CORA NW TOWNHOME DESIGN

ANAYLSIS OF THE PROPOSED MULTI-FAMILY UPDATE
SEATTLE CITY COUNCIL BRIEF
APRIL 2009

Height Limits & Roof Form

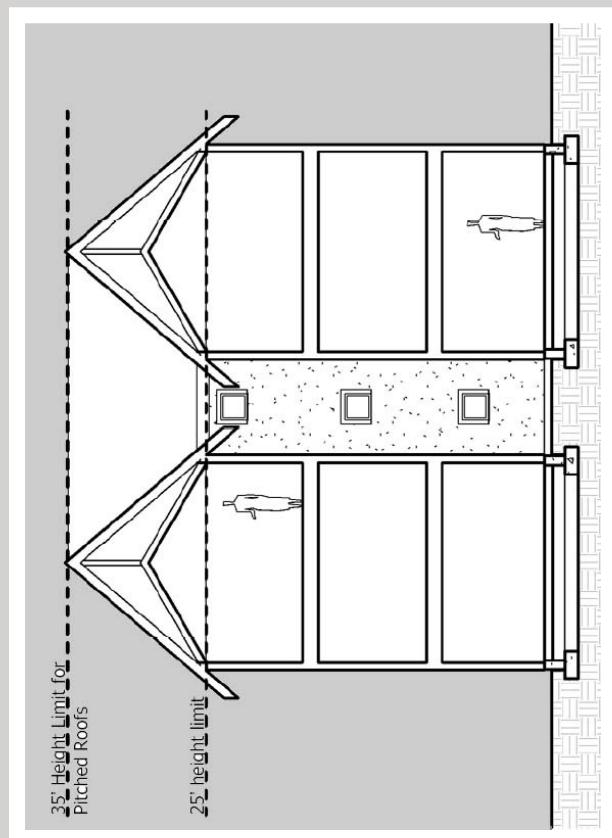
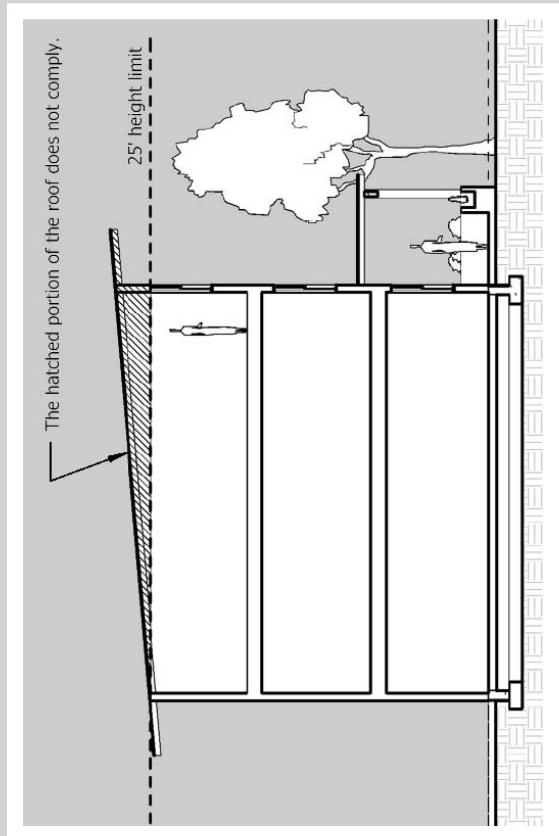
Issue: One reason various townhouses are so much alike is that height limit exceptions have historically been biased in favor of gabled roof forms. The code contains a strong bias against other roof forms.

- The bias toward steeply pitched gabled roof forms creates buildings that are taller than necessary. In many instances, flat roofs or low slope shed roofs reduce the overall height of the building and are the better solution for preserving solar access and view corridors for adjacent properties.
 - The height limits for roofs are calculated differently for sheds and gables. In addition to being capricious, this distinction also encourages designers to clip the overhangs off shed roofs.
- Since height limits are by definition non-departable, there is no flexibility built into the system.

Gable roofs with a roof pitch of 6:12 or greater get a 10' height bonus.

Shed roofs get no height bonus.

This version of the building is several feet lower than the previous version, yet it cannot be built under the current code.

Why do we have a code that precludes these building forms?

Which version of the building is lower scale?

Which version blocks less of it's neighbors views?

Which version block less of it's neighbors sunlight?

- Make the height limit definition consistent across all roof types. Measure the height of roofs at the perimeter of the building from the top of the wall. Exempt all overhangs.
- Make a modest height exception for shed roofs. Allowing them half the height exception of a gabled roof would be adequate while still preventing over-scaled facades on the high side of the roof, or;
- Make the height zone between 25' and 30' eligible for departures. This allows nothing outright but provides the flexibility for designers to make the argument that a particular roof form is a good solution for a particular project.
